NORTH LIBERTY PLANNING COMMISSION MEETING NOTICE AND AGENDA

Memo

To: North Liberty Planning Commission From: Dean Wheatley, Planning Director Subject: Site Plan Approval Request (Lot 20, Dahnovan Estates)

LOT 20, DAHNOVAN **ESTATES** IN THE CITY OF NORTH LIBERTY, JOHNSON COUNTY, IOWA

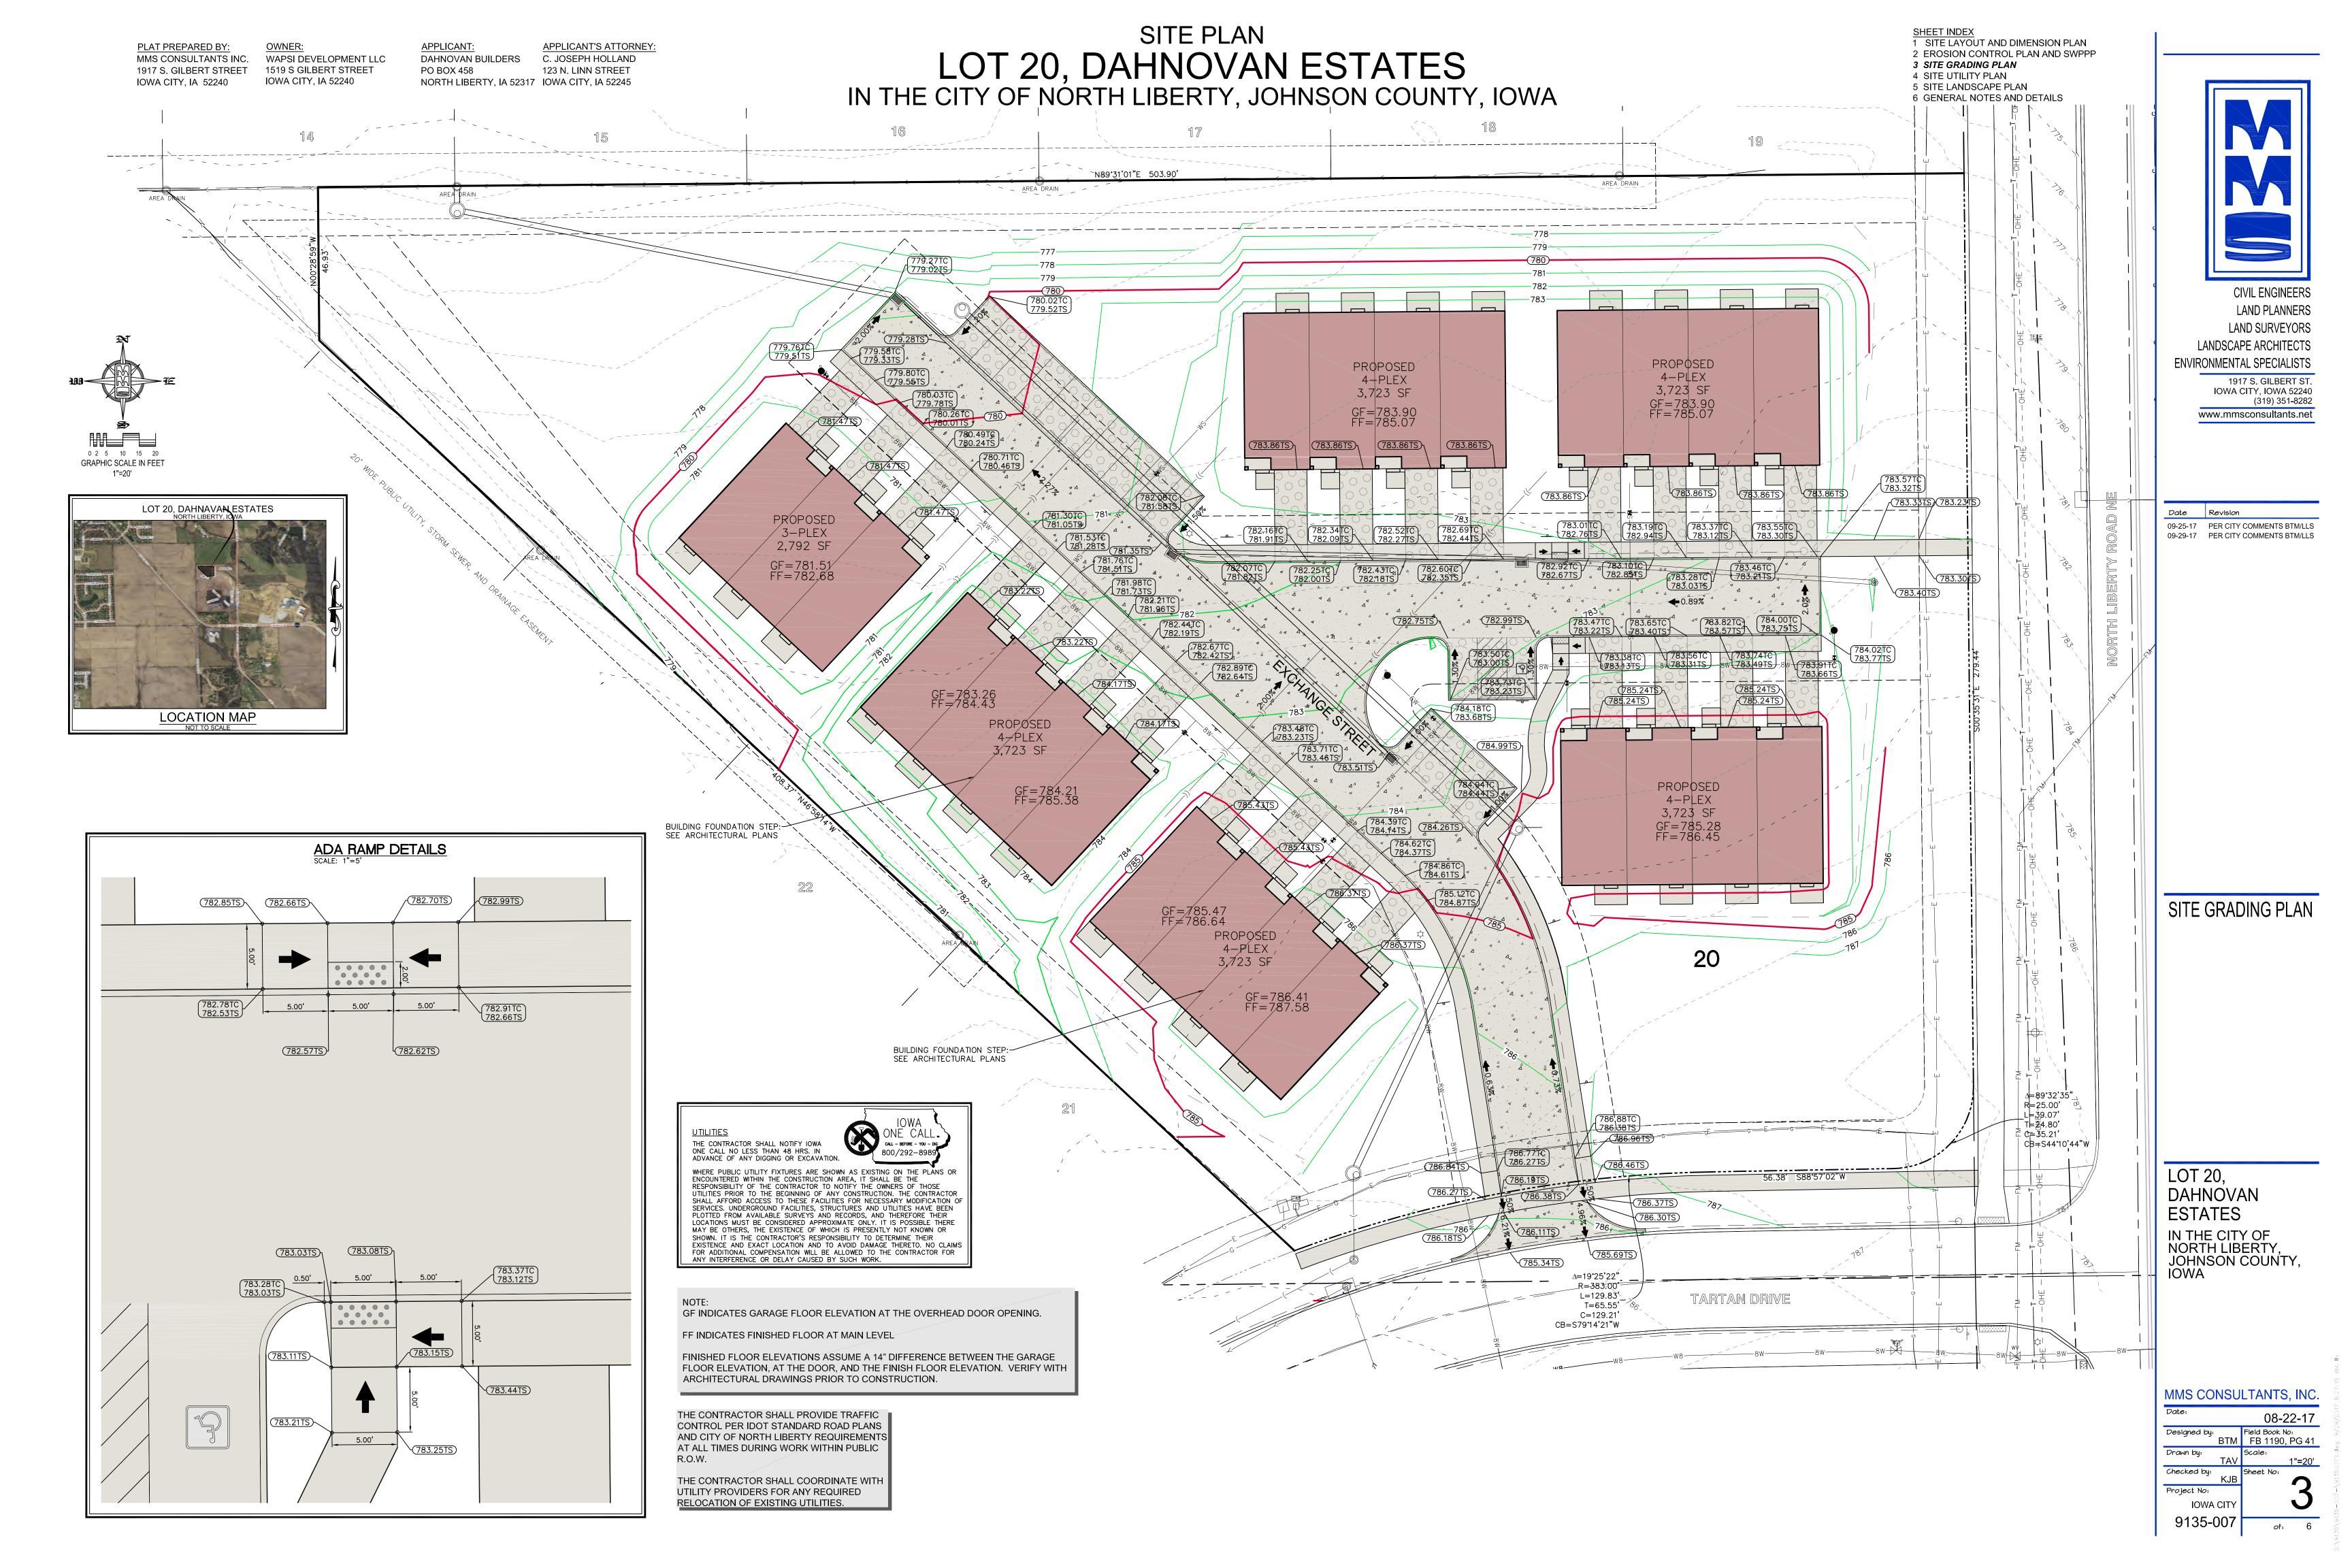
A BMP maintenance agreement is required.

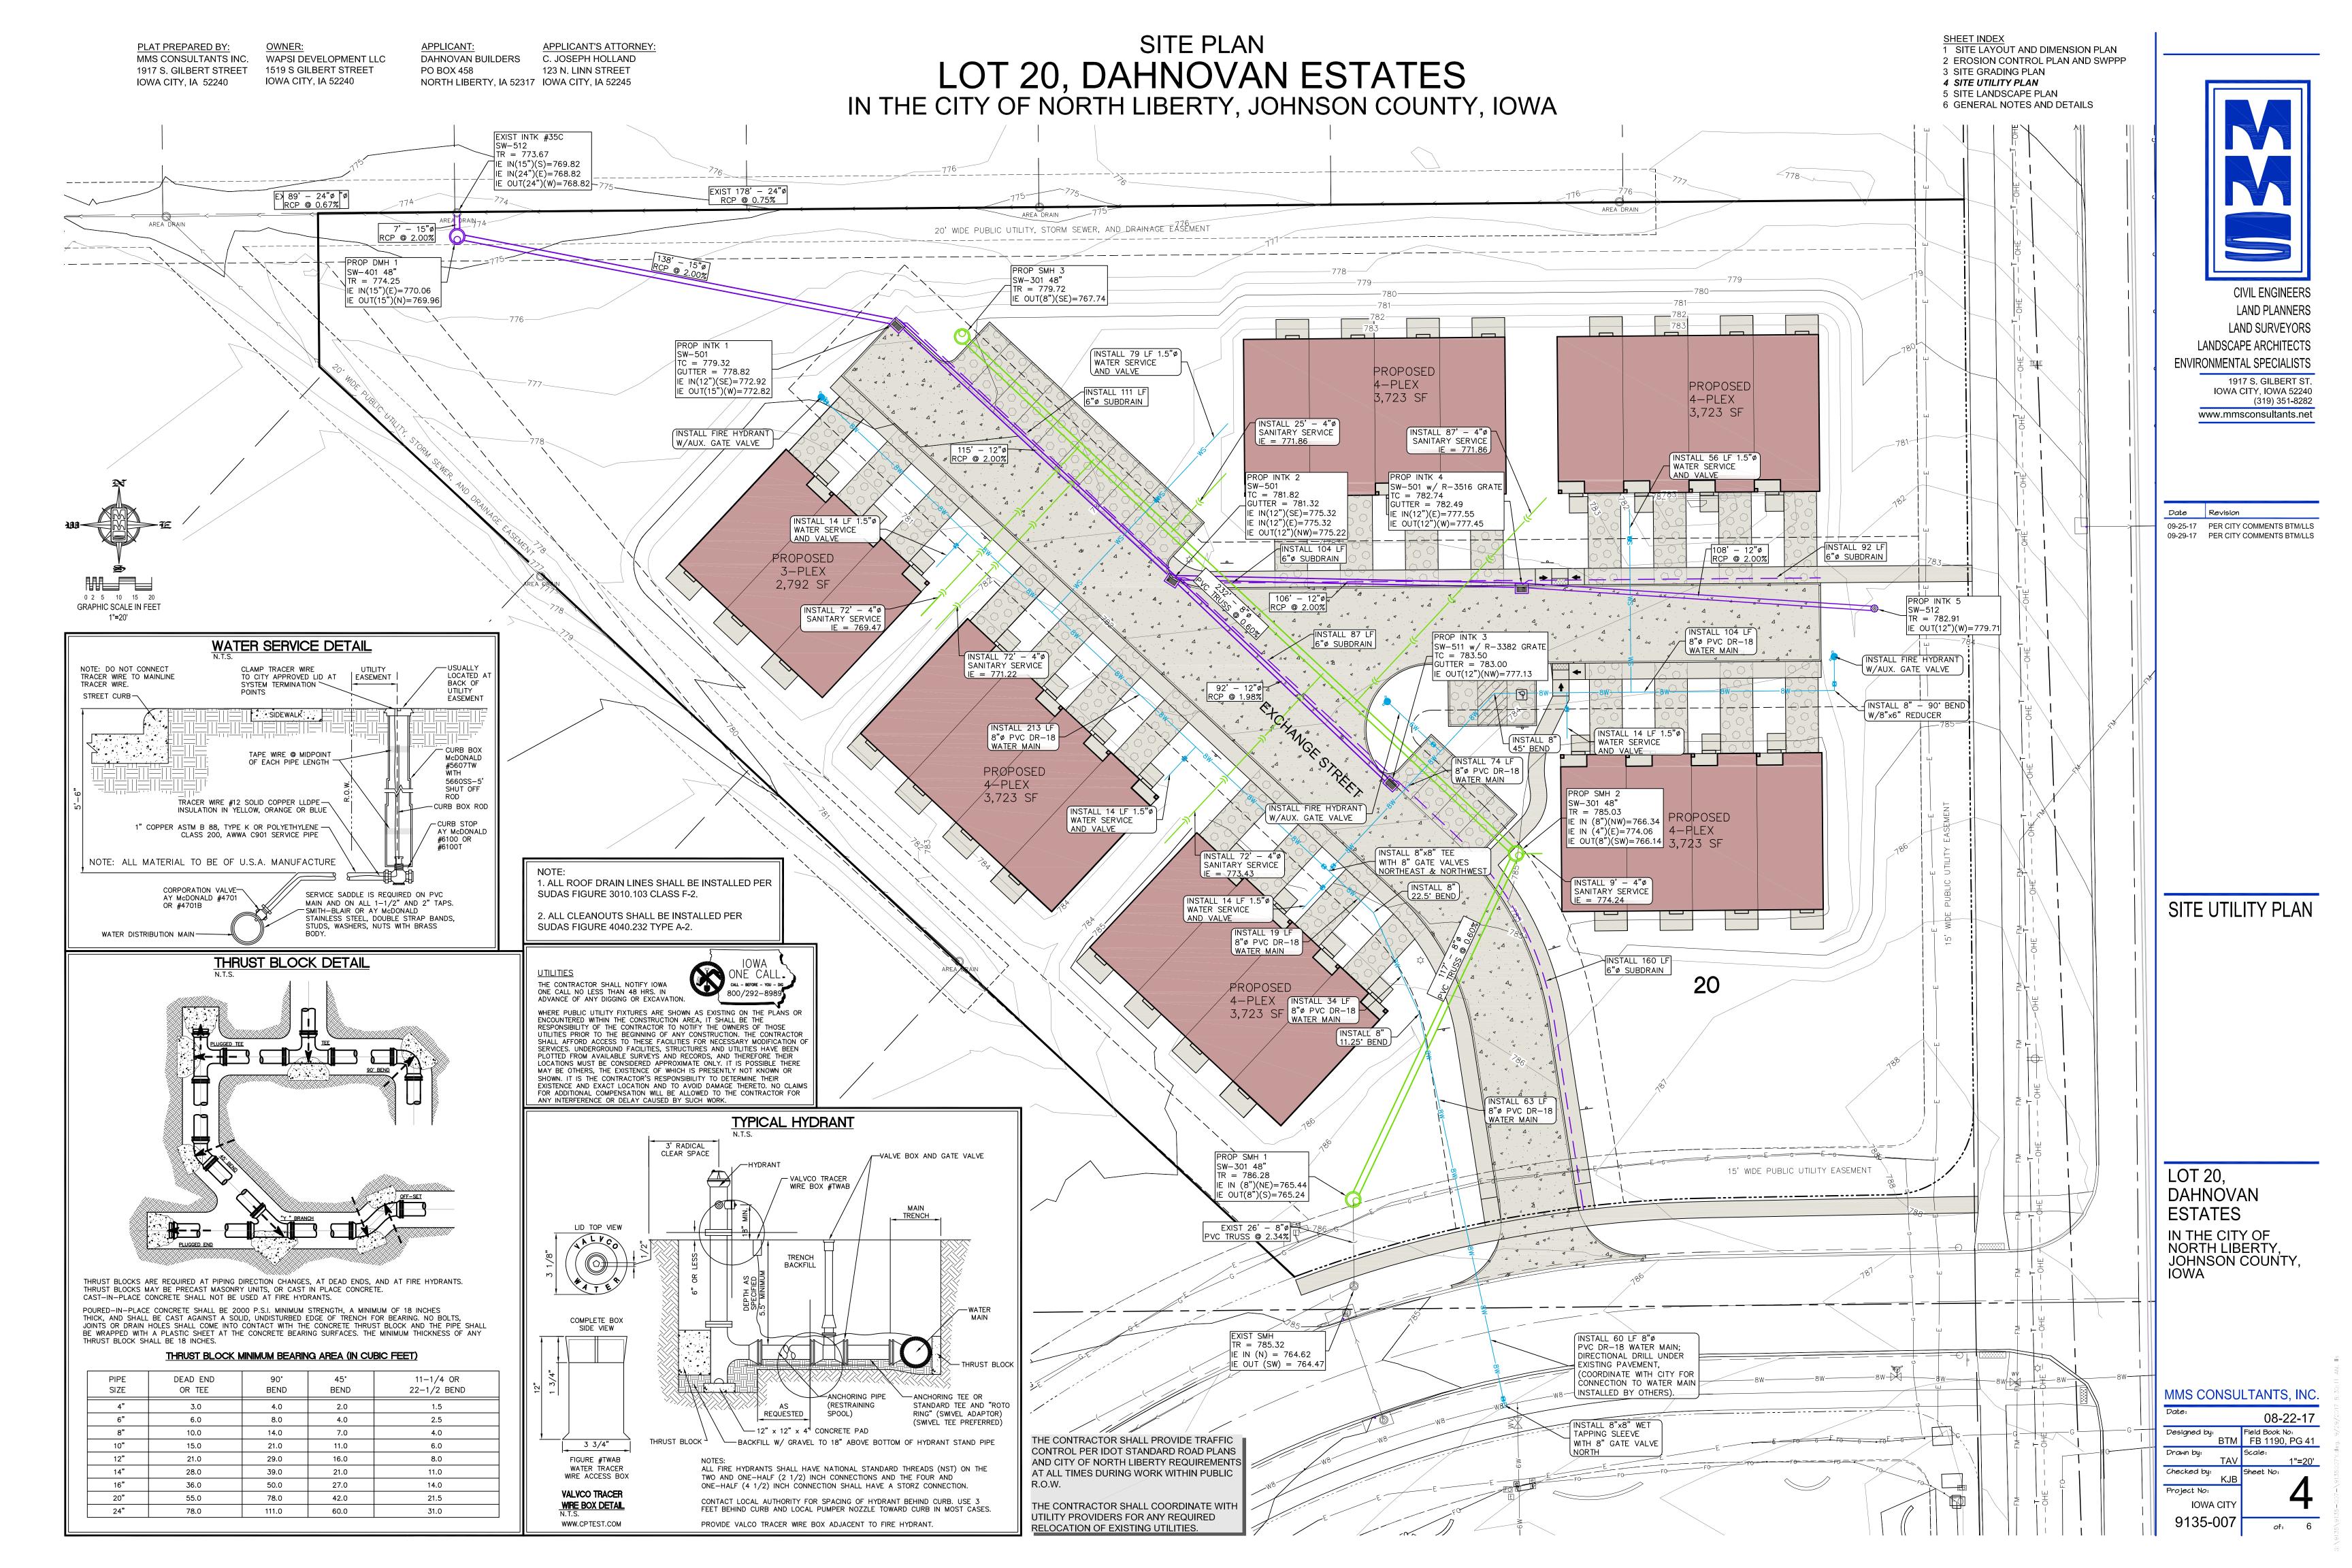
SWPPP will need to be submitted to the stormwater coordinator for approval.

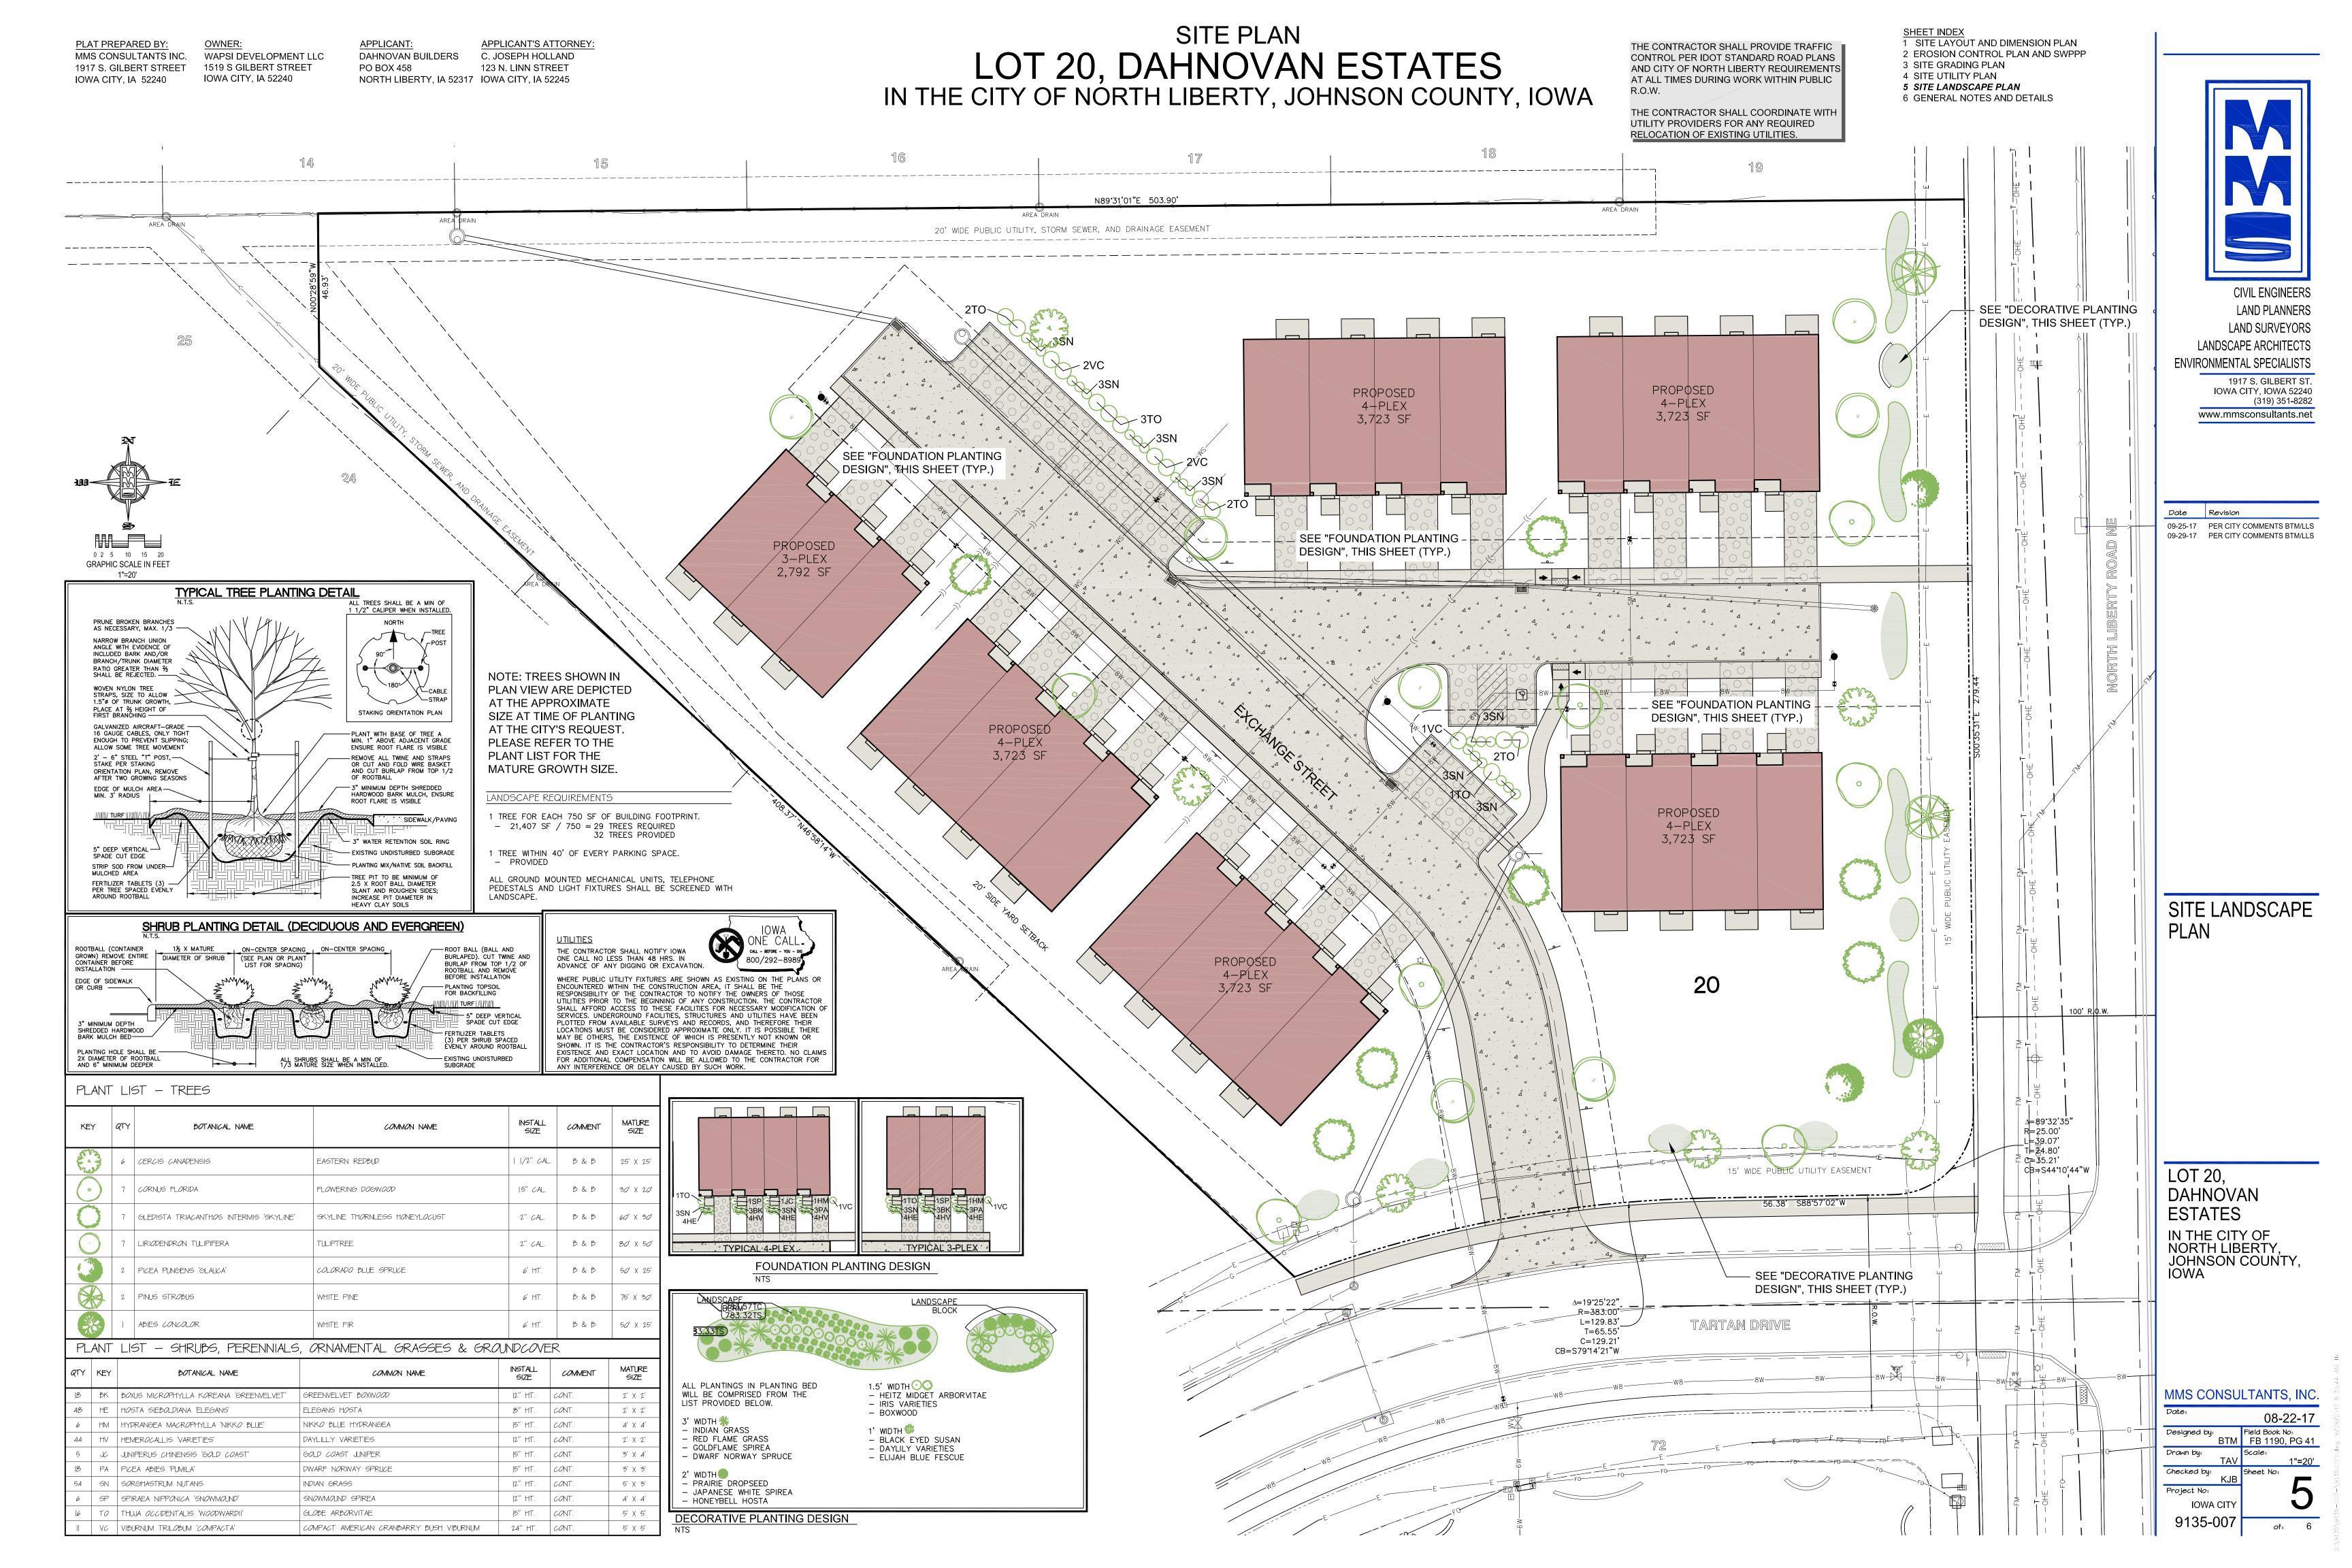
Roads are less than 29' wide, no on street parking will be allowed. "No parking" signs are required.
